SUBJECT: **Addendum No. 2**
U.S. 50/Silva Valley Parkway Interchange – Phase 1
PW 12-30647, CIP No. 71328

U.S. 50 / Silva Valley Parkway Interchange – Phase 1
Contract No. PW 12-30647, CIP No. 71328
Addendum No. 2

EROSION CONTROL PLAN
 SCALE: 1"=50'
EC-2

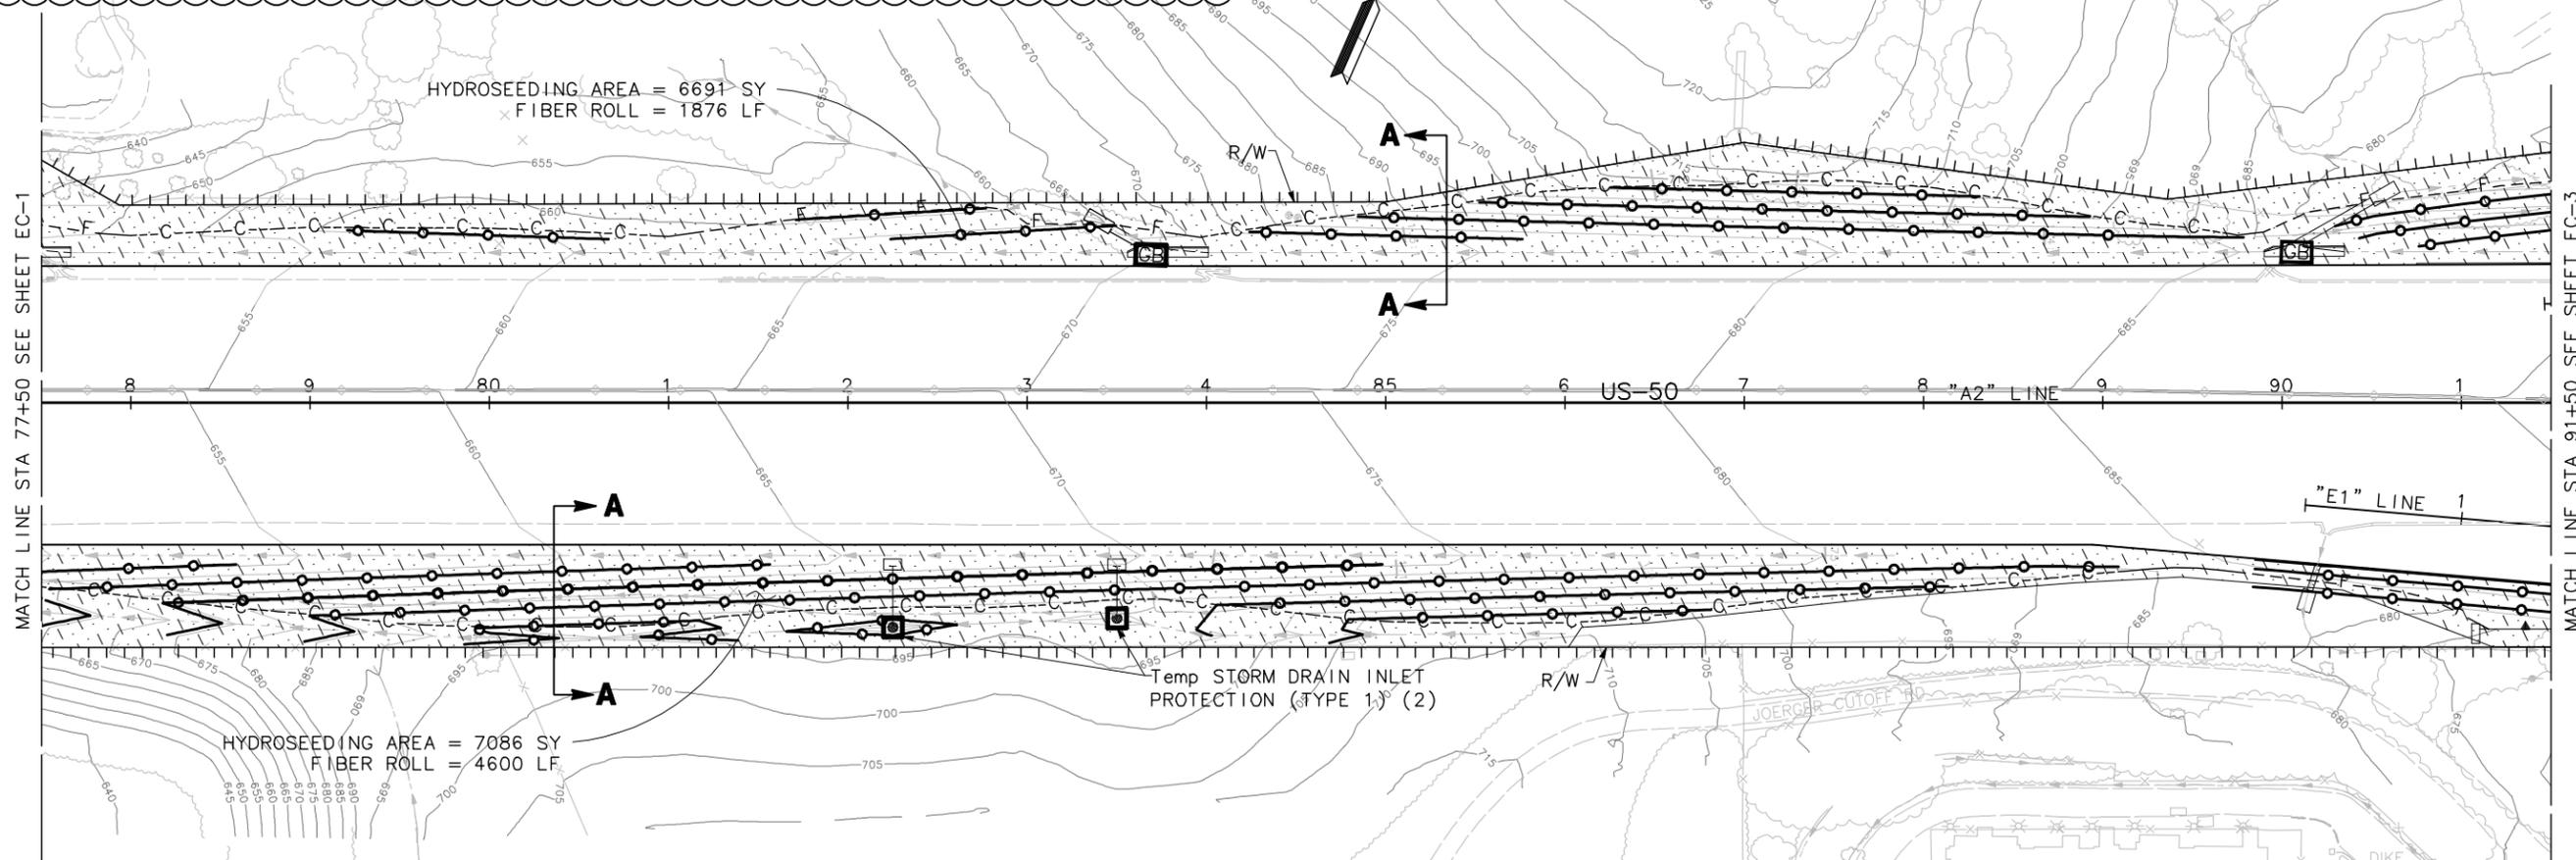
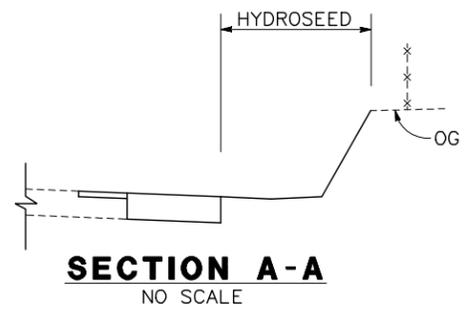
2. 9.	Plan sheet EC-2 (sheet 85); SP-88	Refer to response to Bidders' Inquiries No.4 Item 4.6: Bidders are instructed to replace Plan sheet 85 with revised Plan sheet 85 attached to this Addendum. Bidders are instructed to replace section 20-7.02D(1)(d) of the Standard Specifications and section 21-2 "BIOSWALE" of the special provisions with Attachment C attached to this Addendum. Add the following to SP-88 under section 21: "Add to section 21-1.04: Straw and hydromulch are paid under Hyrdoseed."

09-04-2013	SEE MIX AND HYDROSEED TABLES	JMN	DWM
MARK DATE	DESCRIPTIONS	BY	CH'D
REVISIONS
